PRIVATE SEWAGE SYSTEM INSPECTION REPORT
(ATTACH TO PERMIT)

County:	SHEBOYGAN
Sanitary Permit No.:	321240 / # 6739 ooy.
State Plan ID No.:	–
Parcel Tax No.:	# 267815 T9-32-HIQUIT.14

Permit Holder's Name: PAT EBERT N7628 Royal & Ancient Dr.	☐ City ☐ Village ☒ Town of: RHINE	
CST BM Elev.: 100.00	Insp. BM Elev.: 100.00	BM Description: Top of Telephone Ped # 2298

ADDITIONAL COMMENTS AND SKETCH

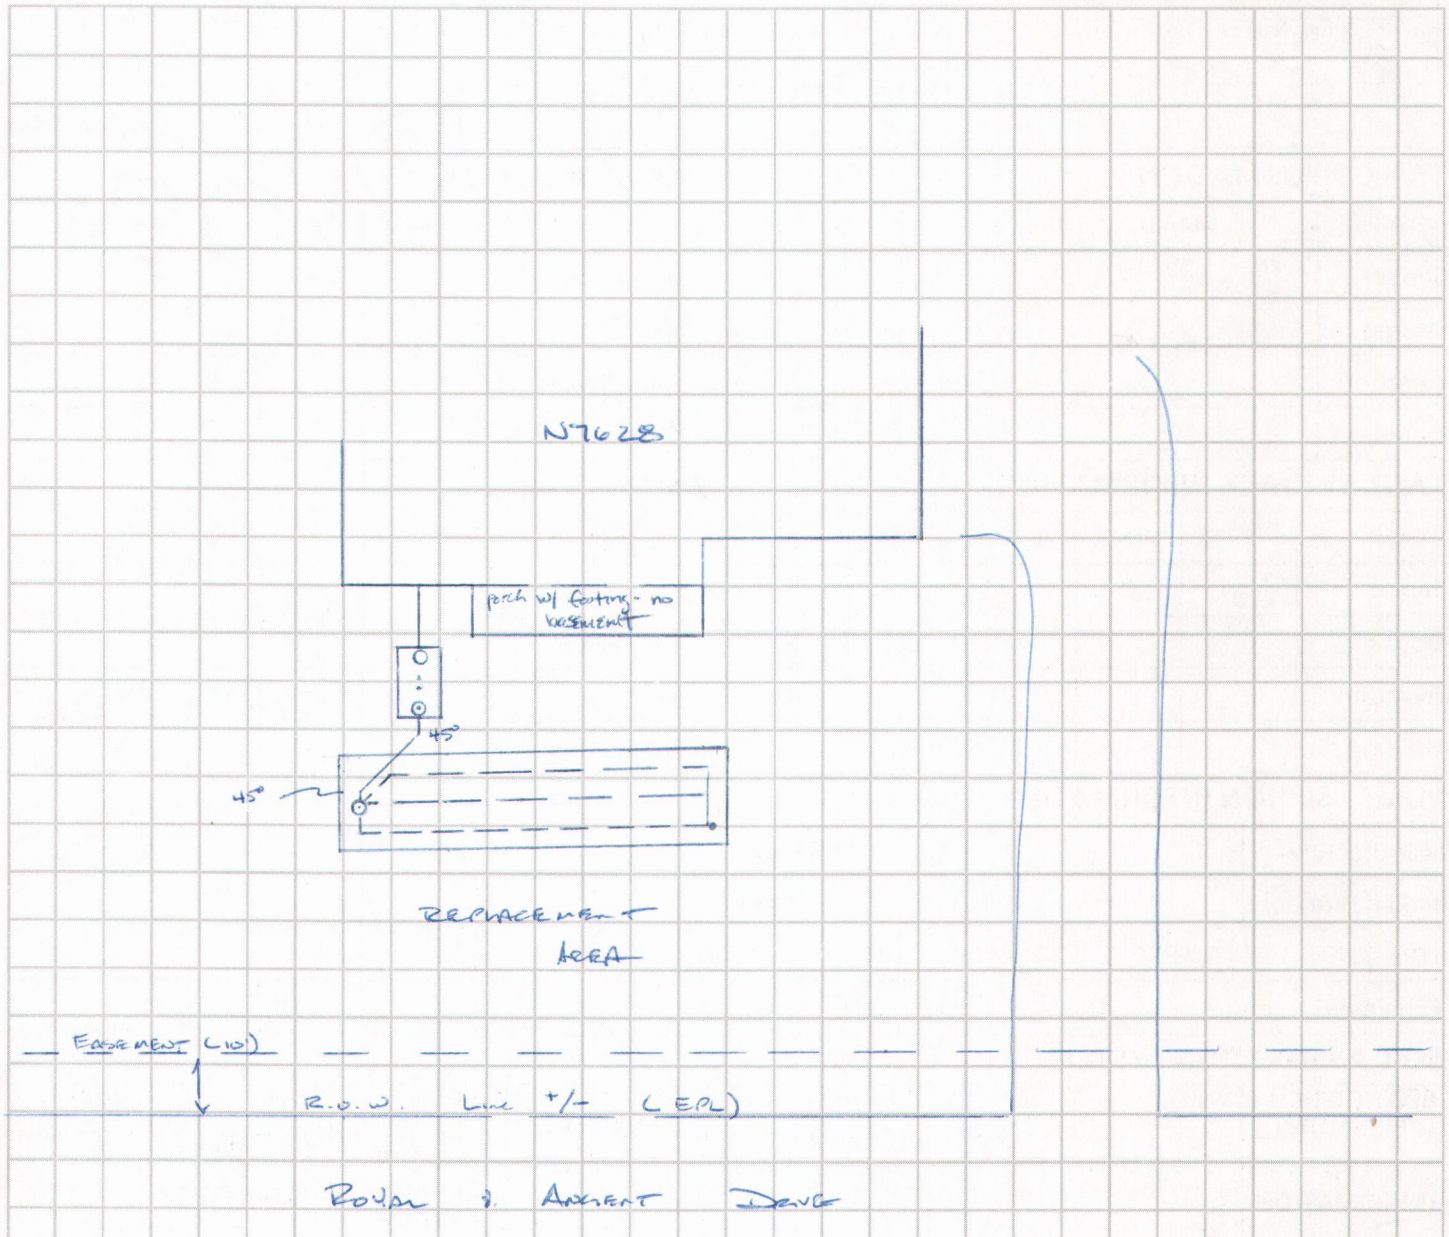
10-15-98 MM & KS on-site w/ J. Hand (MP 223582); obs. bldg. SEWER, TANK, EFFLUENT LINE, DIST. SYSTEM. REVISION REC'D ON-SITE FROM INSTALLER

Plan revision required? ☒ Yes ☐ No
Use other side for additional information.

- All SCH 40 bldg sewer & effluent line
- 3/4" STONE BEDDING
- ZABEL A-100 as outlet baffle on second septic tank compartment
- 12" riser on ea. S.T. manhole
- headers are solid wall SDR 35
